STANDARD DEPARTURE CHART - INSTRUMENT

RJNH / HAMAMATSU

INSTRUMENT APPROACH CHART

ATSUMI FIVE DEPARTURE

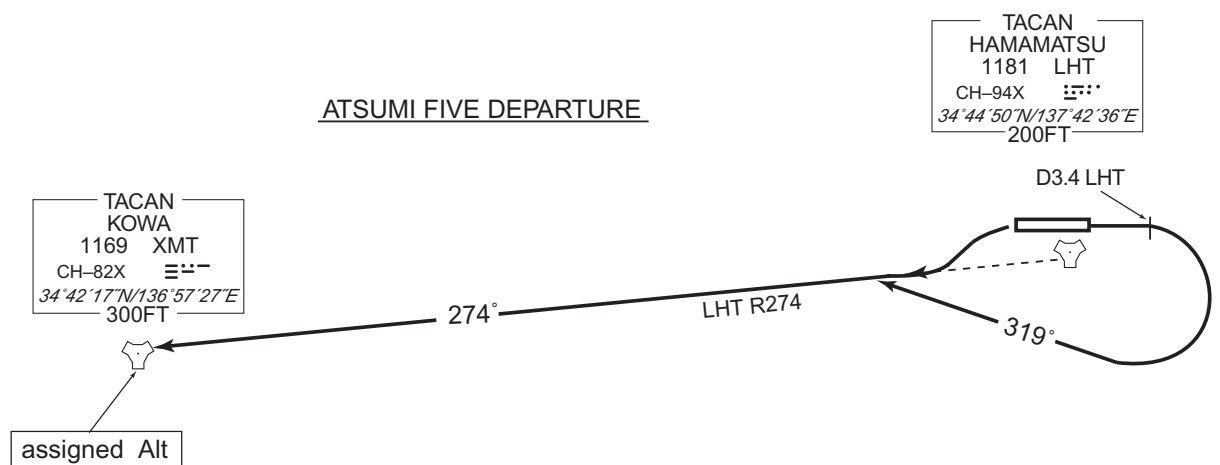
CHANGE : PROC renamed. PROC course. Note deleted.

HAMAMATSU REVERSAL THREE DEPARTURE

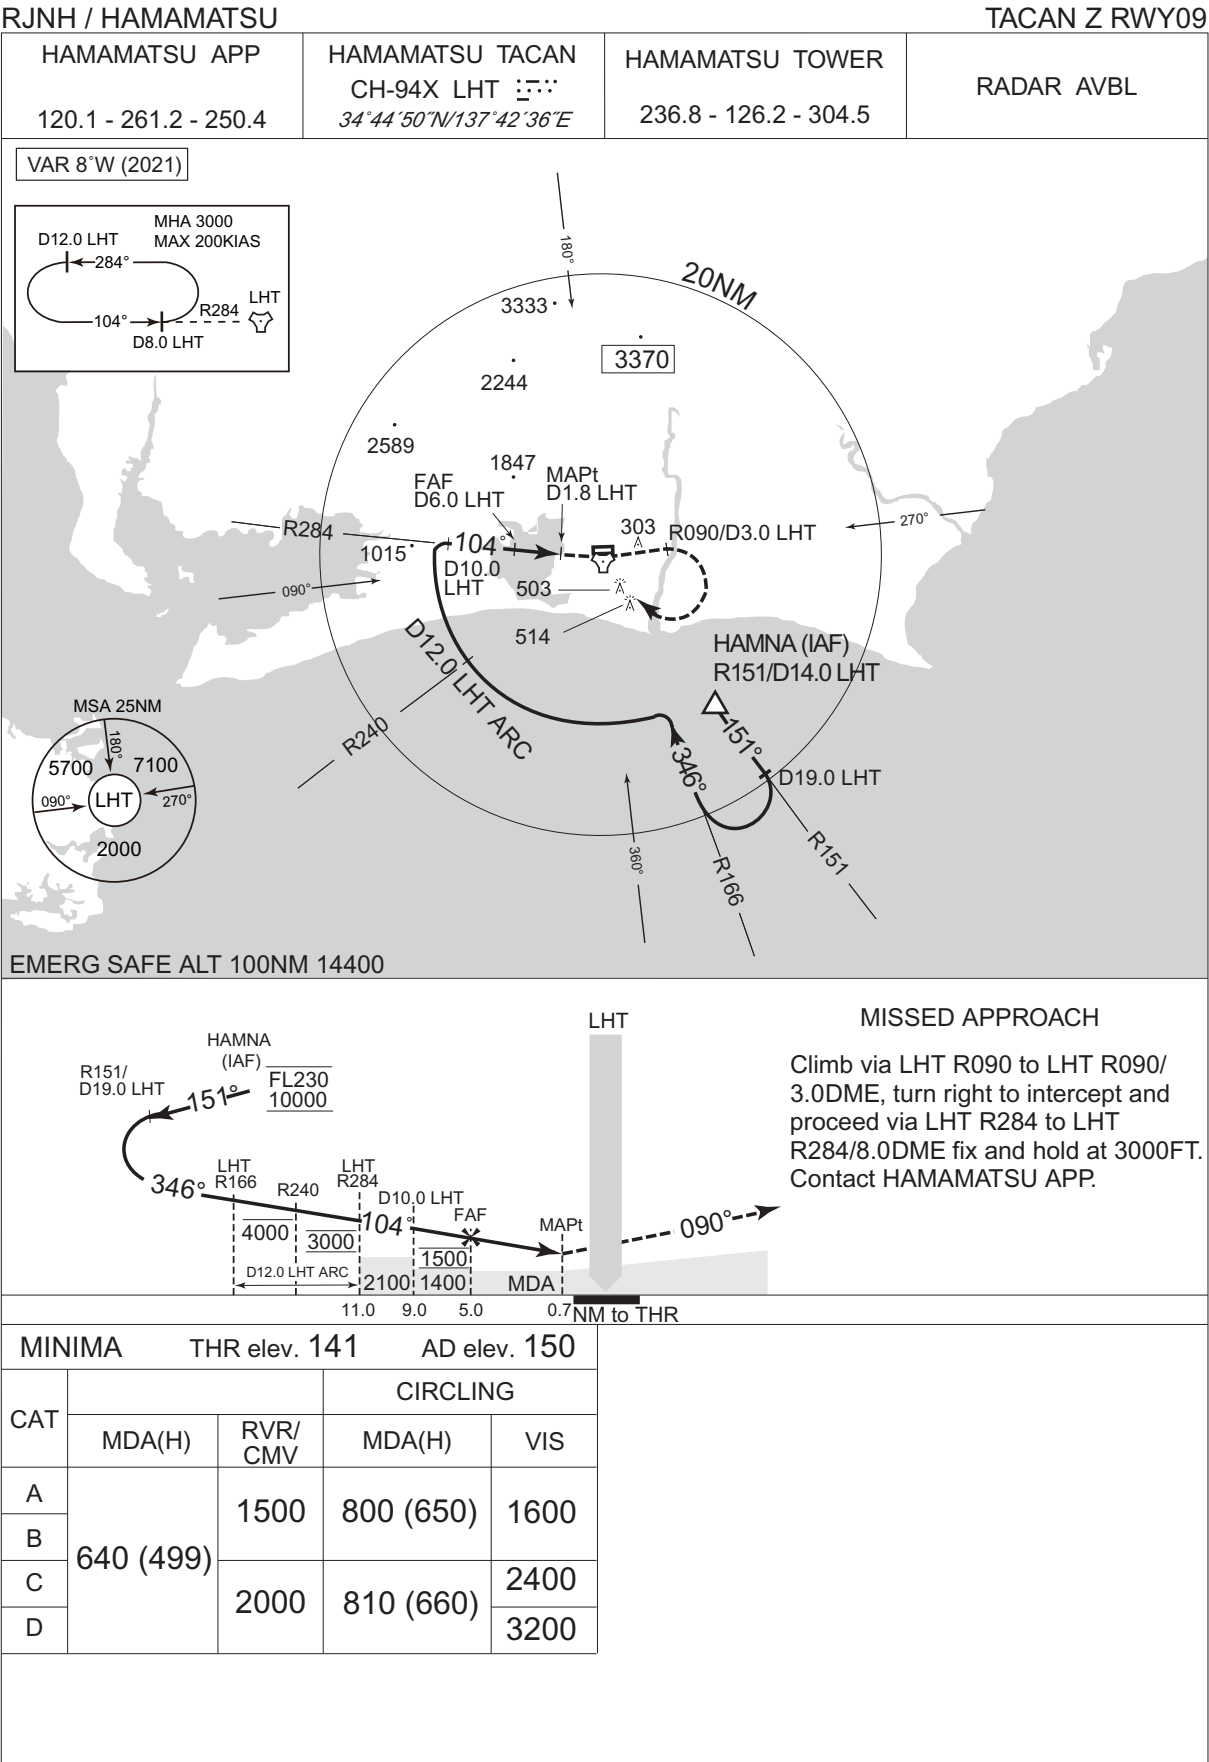
CHANGE : PROC renamed. PROC course. Note deleted.

TACAN Y RWY09

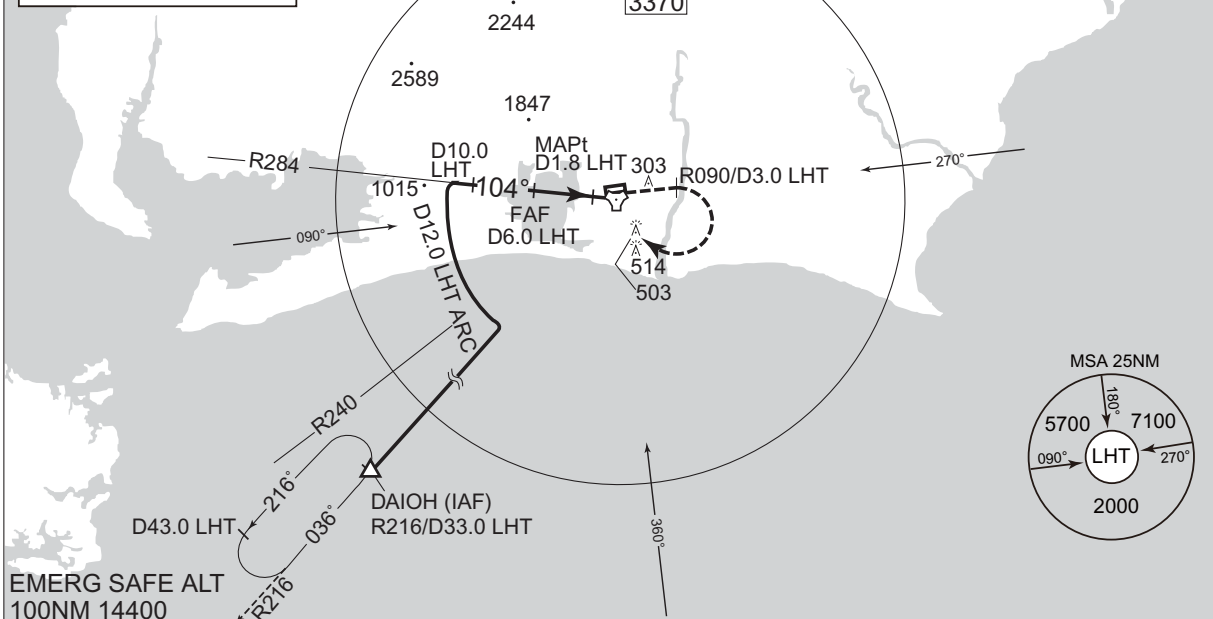
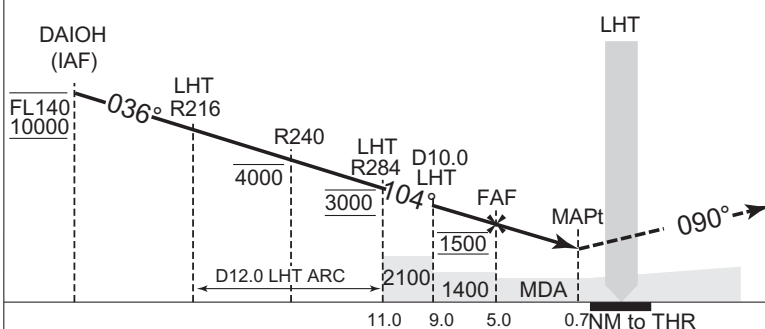
CHANGE : VAR. PROC renamed. PROC course. Description of FAF, MAPt added. OBST added(HGT 303).
OBST deleted(HGT 410, 504). MISSED APPROACH course. ALT restriction(DAIOH). OCA/H added. MDA(H) for CIRCLING.

TACAN Z RWY27

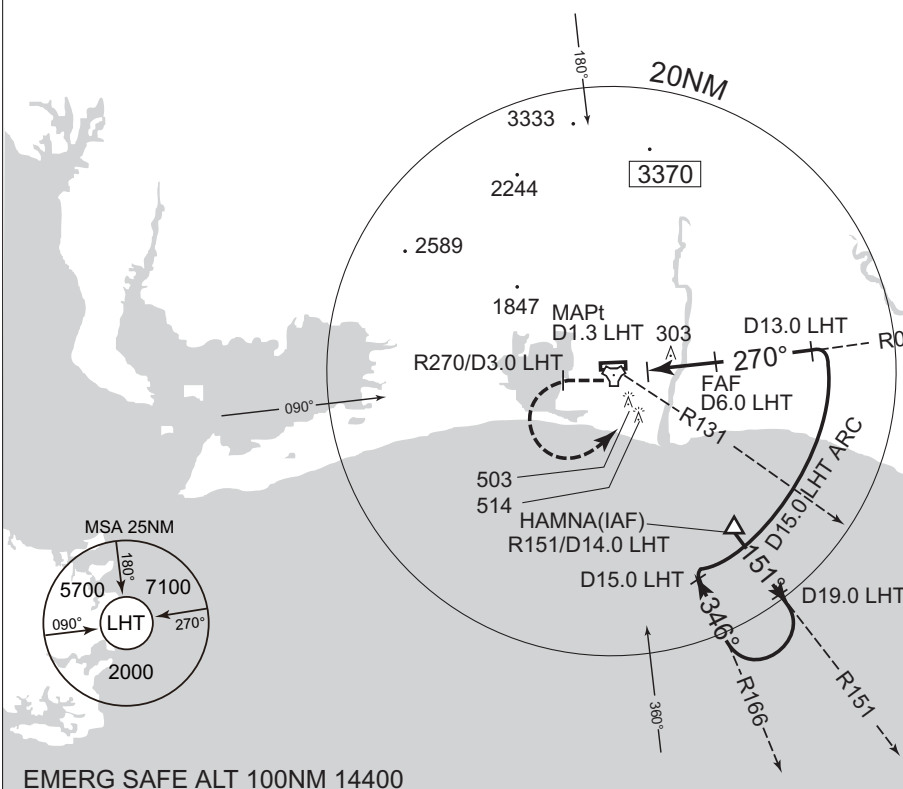
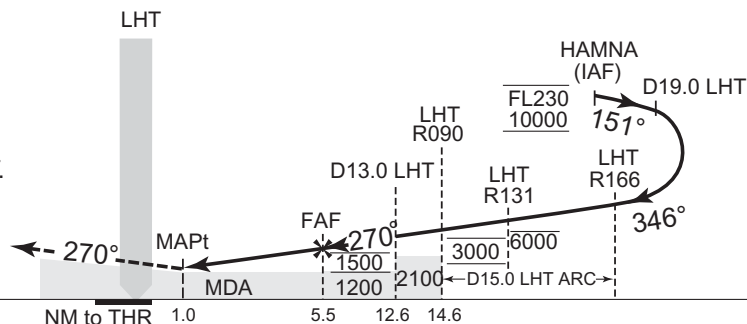
CHANGE : VAR. PROC renamed. PROC course. Description of FAF, MAPt added. OBST added(HGT 303).
OBST deleted(HGT 410, 504). MISSED APPROACH course. ALT restriction(LHT R090). OCA/H added. MDA(H). MDA(H) for CIRCLING.

TACAN Y RWY27

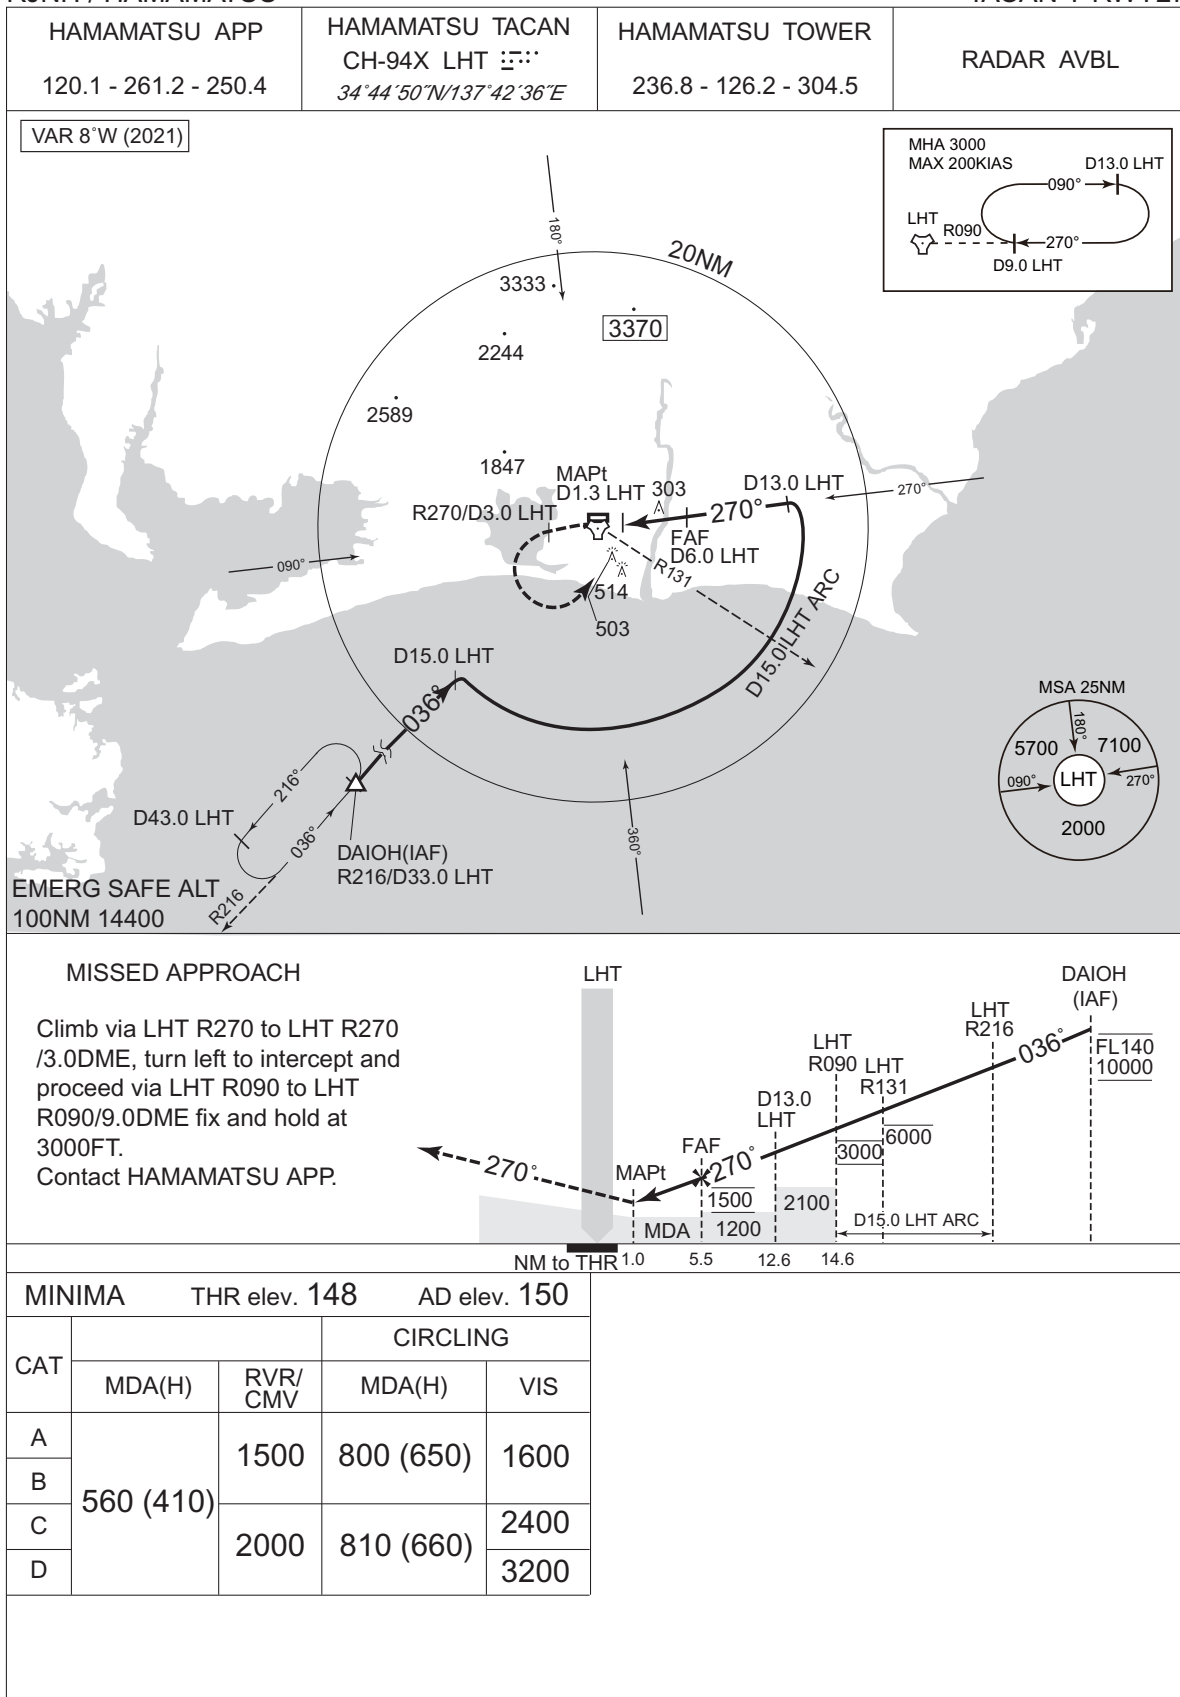
CHANGE : VAR. PROC renamed. PROC course. Description of FAF, MAPt added. MSA. HLDG pattern added. OBST added(HGT 303). OBST deleted(HGT 410, 504). MISSED APPROACH course. ALT restriction(DAIOH, LHT R090). OCA/H added. MDA(H). MDA(H) for CIRCLING.

INSTRUMENT APPROACH CHART

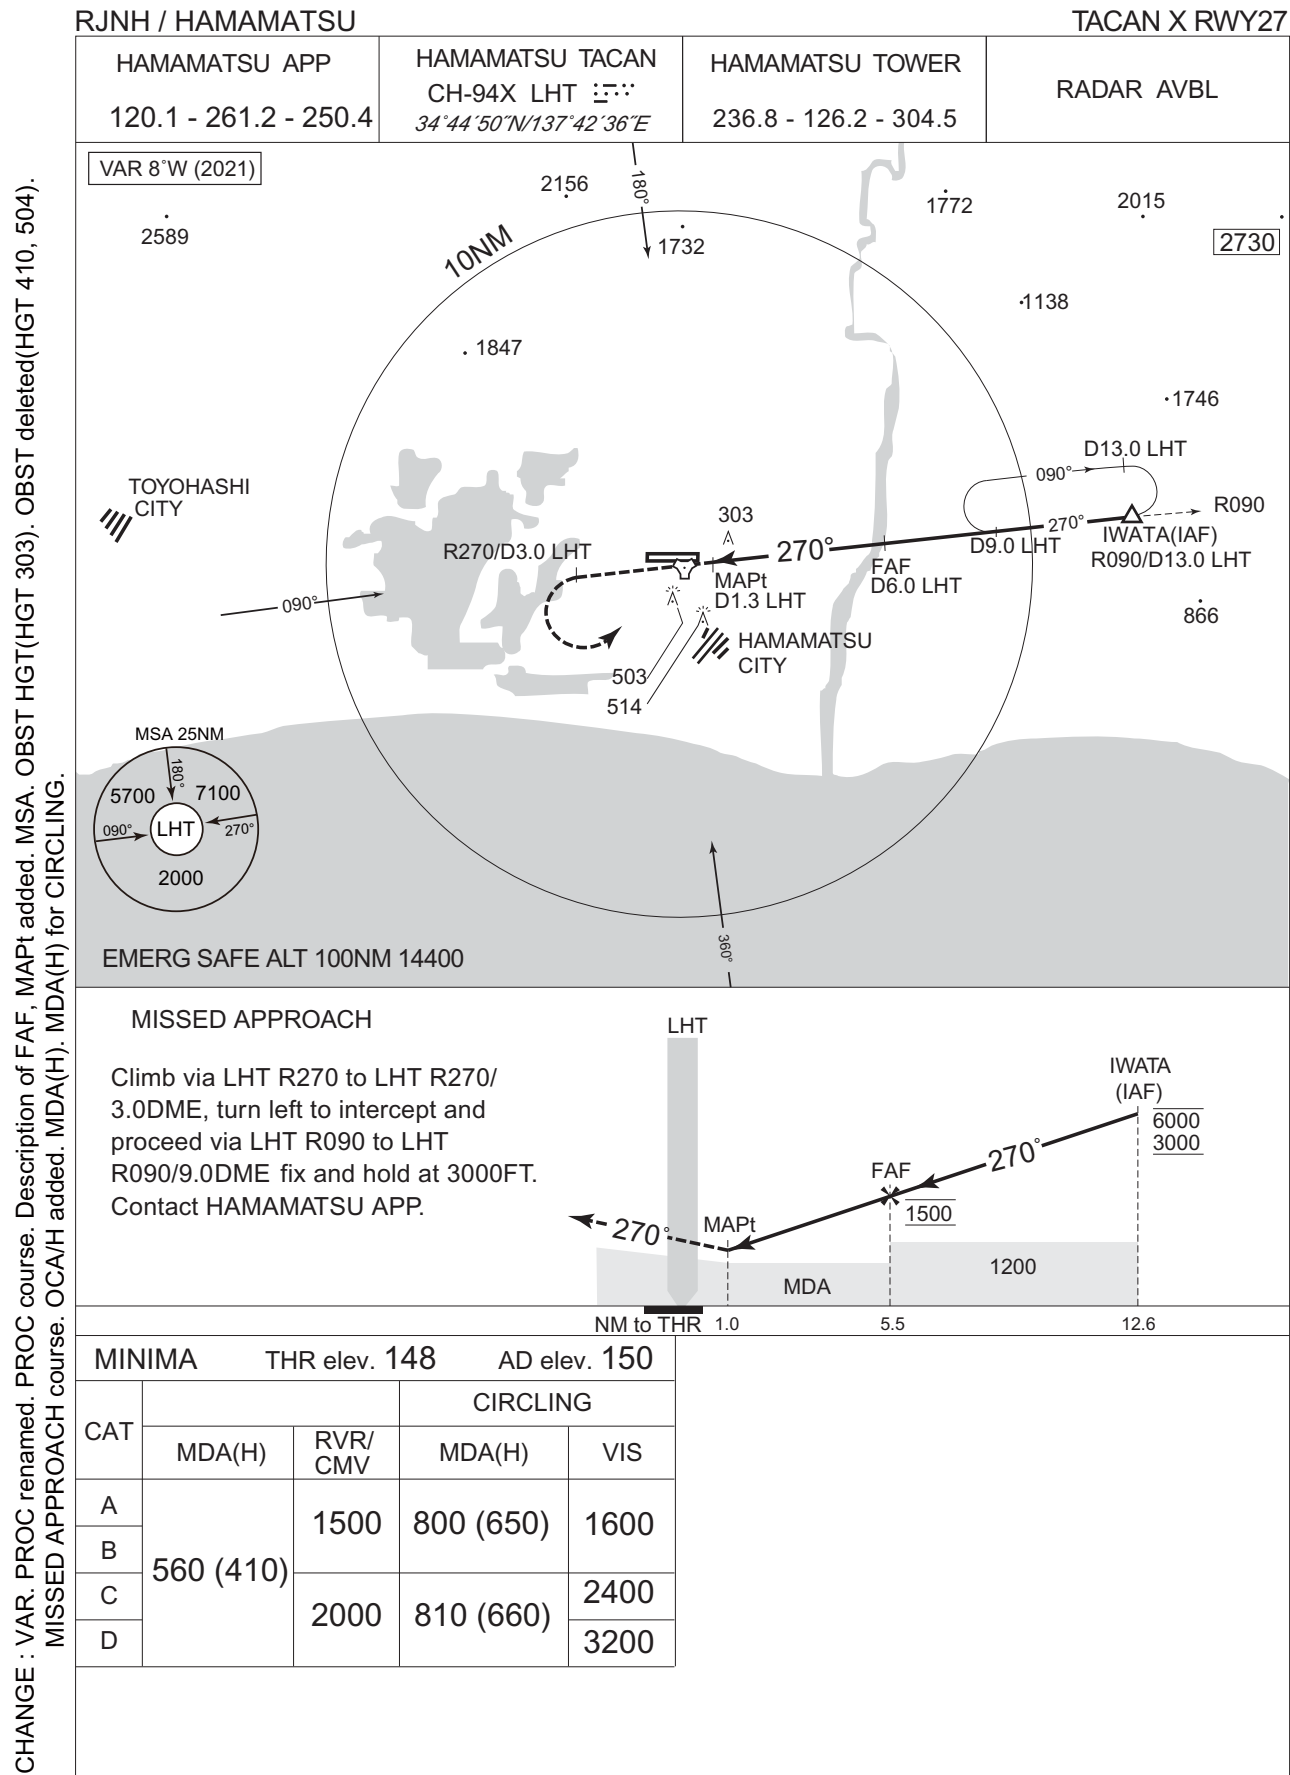
CHANGE : VAR. PROC renamed. PROC course. Description of FAF, MAPt added. MSA. OBST HGT(HGT 303). OBST deleted(HGT 410, 504). MISSED APPROACH course. OCA/H added. MDA(H). MDA(H) for CIRCLING.
